March 10, 2021

**Re: AHRI-HRAI Comments on March 5, 2021 Technical Webinar Regarding
Central Air Conditioners and Heat Pumps**

Figure 1 Normalized Tested Capacity and Calculated H4 of a 5-ton single-stage Heat Pump to Appendix M1

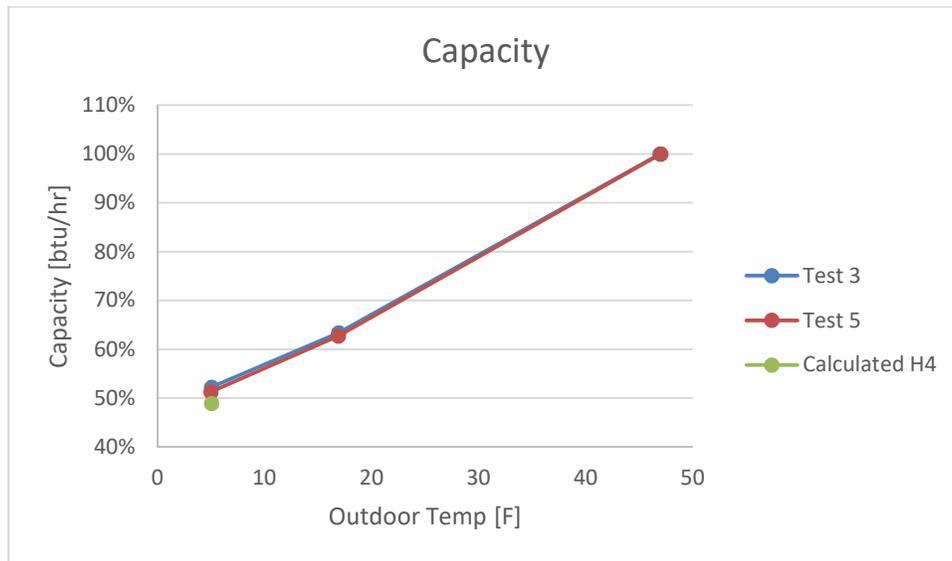
Fundamentally, the Appendix M1 test procedure, while offering an option for testing at 5 °F (-15 °C) (H4), provides all the relevant information for the calculation of the capacity and performance of the products at 5 °F (-15 °C), without conducting the test at that temperature. Extrapolation of the slope of the line between 47 °F (H1) and 17 °F (H3), for both capacity and COP, down to 5 °F will yield virtually the same outcome as testing the product at 5 °F. The data set is limited but includes two tests of the same unit at different times to assess repeatability, as very few products have been tested to Appendix M1, however, AHRI has test data for a 5-ton single-stage unit. The data has been normalized based on capacity at 47 °F. **The graphs, below, show there is minimal difference (around 3-percent) between performance and capacity derived through calculation or testing at 5 °F.**

One would not expect to see significant difference between testing and calculation as Appendix M1 requires H4 testing to be conducted at the same compressor speed as H1 and H3 for single-speed, two-stage heat pumps. Appendix M1 requires that all heat pumps for which the 5 °F full-speed test is not conducted, the extrapolation approach using test results for 17 °F and 47 °F temperatures (or the standardized slope factors for variable-speed heat pumps which do not use the same speed for these tests) would be used to represent performance for all ambient temperatures below 17 °F. The 5 °F test is optional because the limited data has shown there is only a small improvement in accuracy in exchange for a significant test burden increase.

In summary, the Joint Commenters request NRCan revise the proposal to require testing at 5 °F (-15 °C) to calculate HSPF2 for Region V. Instead, the Joint Commenters suggest that the 5 °F (-15 °C) test point remain optional, and the efficiency report should permit the COP at 5 °F (-15 °C) and the rated capacity at 5 °F (-15 °C) to be reported based on calculation. This is a reasonable request, given that the entirety of the NEEP data used in NRCan's analysis is variable speed, therefore not representative of the market, and also derived exclusively through calculation.
